February 9, 2004

Subject: Response to NRC Request for Additional Information Regarding Relaxation Requests 1 and 2 for Reactor Pressure Vessel Head Penetration Inspection Requirements in Nuclear Regulatory Commission Order EA-03-009 for San Onofre Nuclear Generating Station (SONGS) Units 2 and 3 (TAC Nos. MC1540, MC1541, MC1542, and MC1543)

Reference: Letter from A. E. Scherer (SCE) to the Document Control Desk (NRC) Dated December 9, 2003; Subject: Docket Nos. 50-361 and 50-362 Request For Relaxation Of Reactor Pressure Vessel Head Penetration Inspection Requirements In Nuclear Regulatory Commission Order EA-03-009 San Onofre Nuclear Generating Station Units 2 and 3

Best Case UT Coverage:

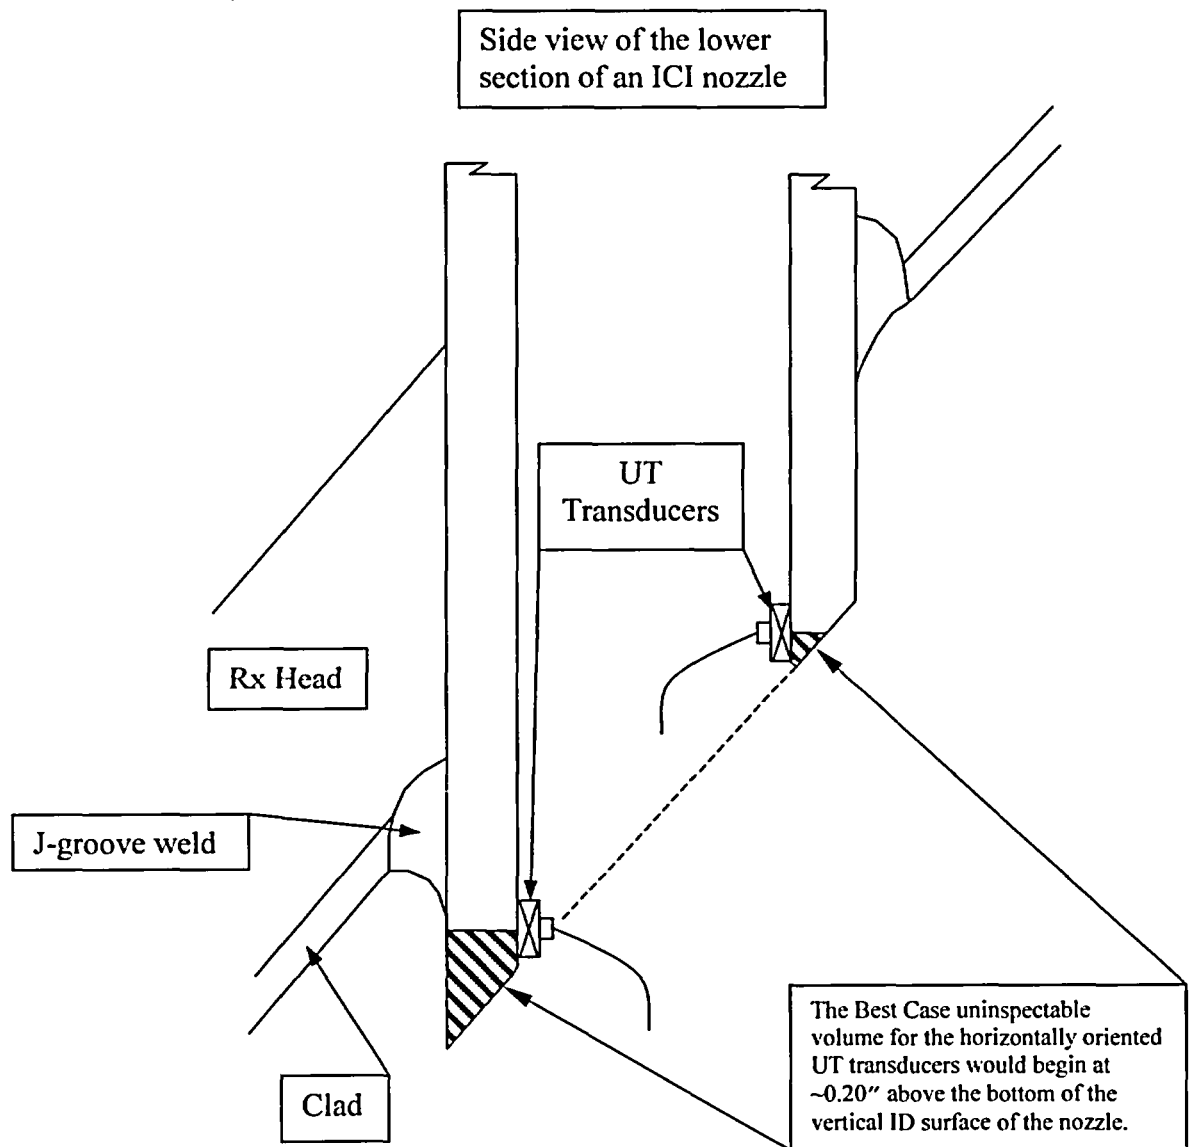
4. Please clarify the third bullet statement concerning the geometry of the ICI penetrations that cannot be completely examined using UT. Provide a sketch to show the UT coverage on the ICI nozzle. It is stated that ET will be used to inspect the ICI penetrations and thereby allow a more complete examination. It is not clear if the use of ET will provide complete coverage as required in the Order. The licensee is requested to provide clarification.

- b) *Provide a sketch to show the UT coverage on the ICI nozzle.*

A design drawing (SO23-901-89) providing detailed dimensions of the ICI nozzle is provided as Attachment 4. The sketches provided below are intended to aid in visualizing the location of the uninspectable volume using UT examinations, and

are not meant to be taken as accurate depictions of the nozzle geometry. The sketches are not to scale.

The best case sketch shows the uninspectable volume at the bottom tip of the ICI nozzles that results from the nozzle shape. The expected case sketch shows the uninspectable volume due to loss of coupling to the nozzle which is likely a result of nozzle distortion which occurred during installation.
